Caerleon Comprehensive School

Planning Statement

November 2025

PROPOSAL: PRE APPLICATION PLANNING ENQUIRY FOR Demolition of blocks D1 (Learning Hub), D2 (Drama), D3 Peri, G (WBQ), H (Gym), K (Conference) and L (Caretaker house), partial demolition and repurposing of blocks A/B/C (Main block) and creation of new sports and teaching facilities

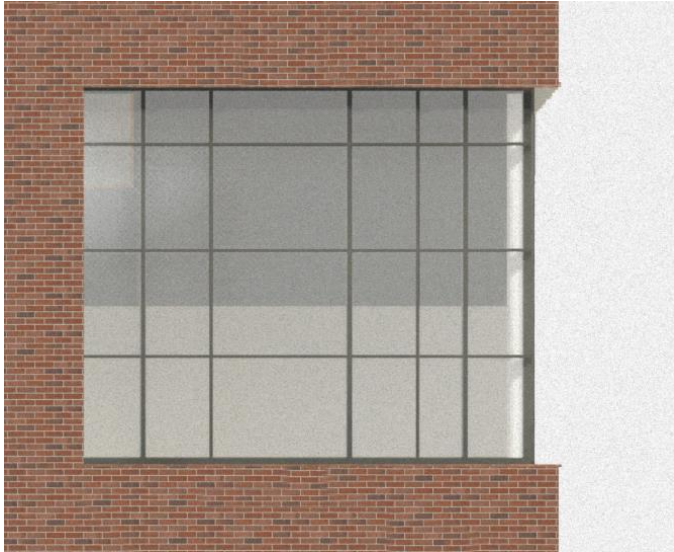
I note the design precedents cited in the DAS which are useful. These photos demonstrate the benefit of natural light in sports hall and gym situations without prejudicing usability:

The Godolphin precedent also shows us how 2 materials or 2 material types, vertical recesses and windows can contribute to the external view without compromising the internal function and encourage visual interaction with the outside sports space.

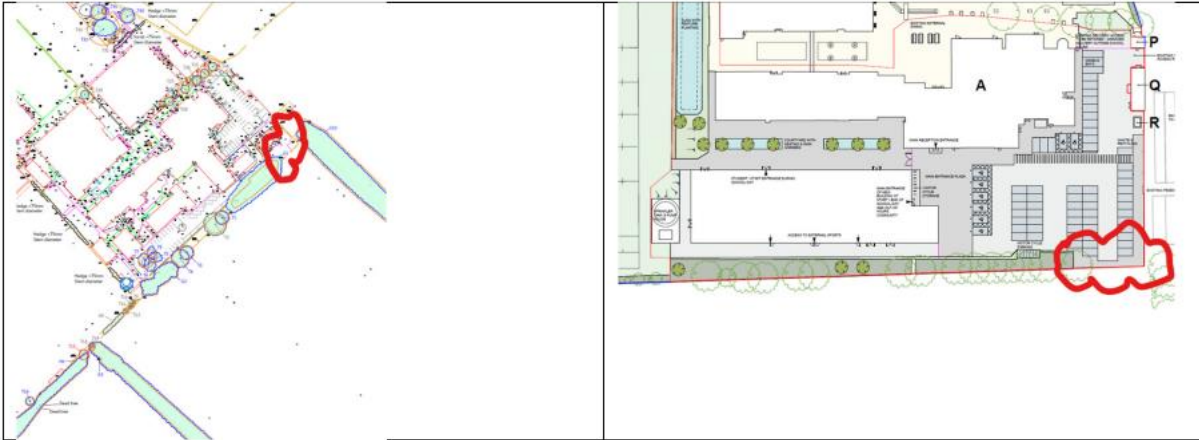
The wrap around glazing shown as serving the activity or drama studio is located at high level and by reason of orientation will flood this space with natural day and sunlight for most of the school day. There does not appear to be any attempt at solar shading (other than what may be achieved by existing landscaping along the southern boundary. There are no objections to the feature but by reason of its size and prominence would be keen to understand reveal details, glazing type (whether clear or coloured), frames and bars etc. The elevations appear to suggest a large reveal that I would welcome. However, this is less clear on the floor plan. How will these reveals be finished as they will be clearly visible?

On the whole, there is no objection to a two storey, flat roof building of predominantly brick construction, of the size proposed in this location. I am of the view that there are aspects that may need further consideration including the materials palette, the arrangement of the southern elevation, the finishes and openings (or lack of) on the western and southern elevations, the fine detailing of large glazing features and the general arrangement, focussing upon the shady northern elevation as the active space in the knowledge that the building itself will encourage more shading in this key circulation area and potentially contribute to wind tunnelling.

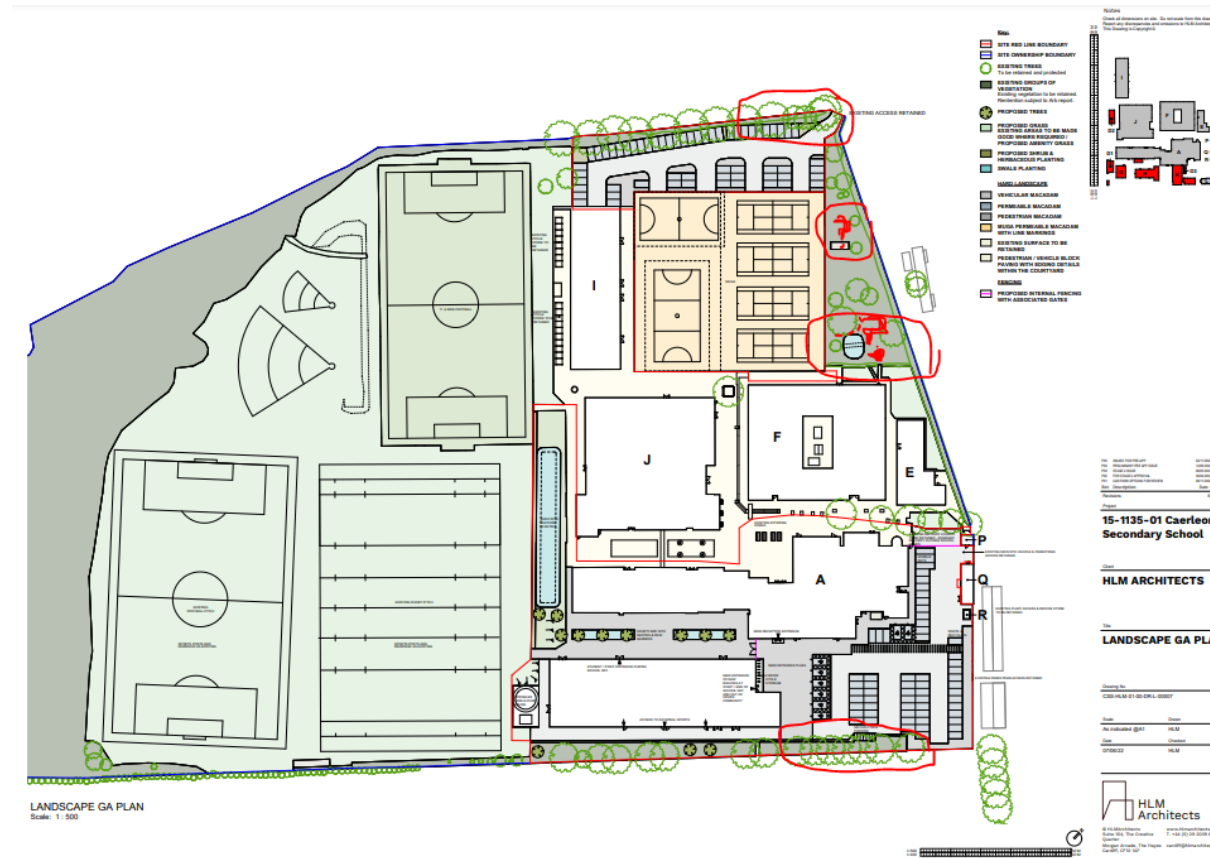
There appears to be an incursion into the RPA of G1 (Tree report) ie proposed car and motorcycle parking and incursion into the RPAs of trees within G9 - see image below.

It should be confirmed that no proposed services bisect the RPAs.

Is there a proposed wall to the front of G1?
